BLUE BIRD

Jumper Cable Routing

MODELS AFFECTED: 2008-2009 BBCV Visions w/ 2007 Cat Engines

S08MY SERVICE BULLETIN

Firewall (Engine Side)

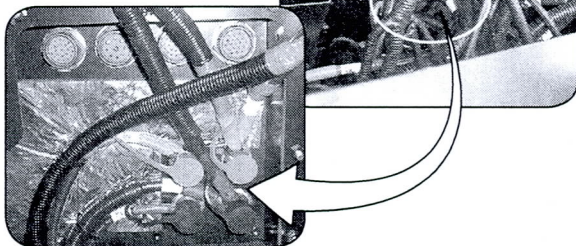
- 1** Park vehicle on a level surface, apply parking brake, turn engine off, remove ignition key and chock wheels.
- 2** Disconnect batteries.
- 3** Open engine hood and locate the Chassis Power and Electrical Power Studs.

Incorrect Routing

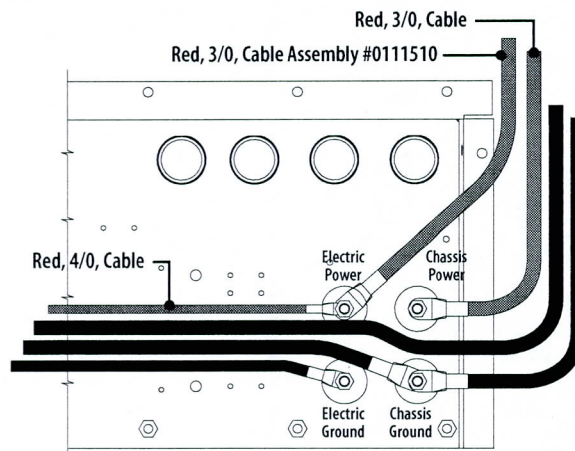
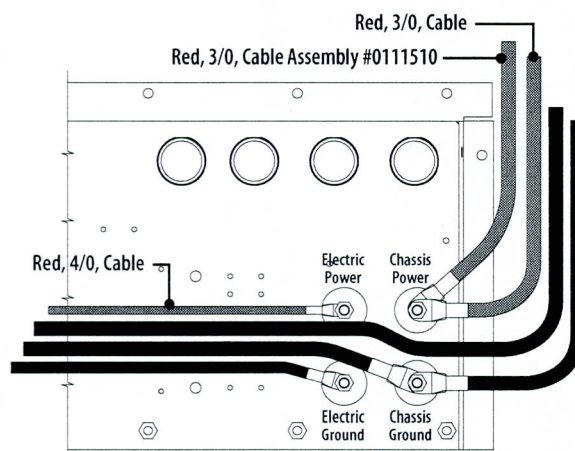
On these buses the positive jumper cable is routed incorrectly. As a result, the engine may experience shutdown after initial start up. To correct this condition, the jumper cable should be moved from the electrical power stud to the chassis power stud according to the instructions provided in Service Bulletin S08MY.

Relocate positive jumper cable from Electrical Power Stud to Chassis Power Stud.

- 4** The lower end of Cable Assembly 0111510 should be attached to the Chassis Power Stud. If the cable is in this location, no further action required. If the lower cable end is attached to the Electrical Power Stud, remove it and attach it to the Chassis Power Stud.
- 5** Tighten both stud nuts to 11- 15 ft-lbs and apply a corrosion protection such as red glyptal.
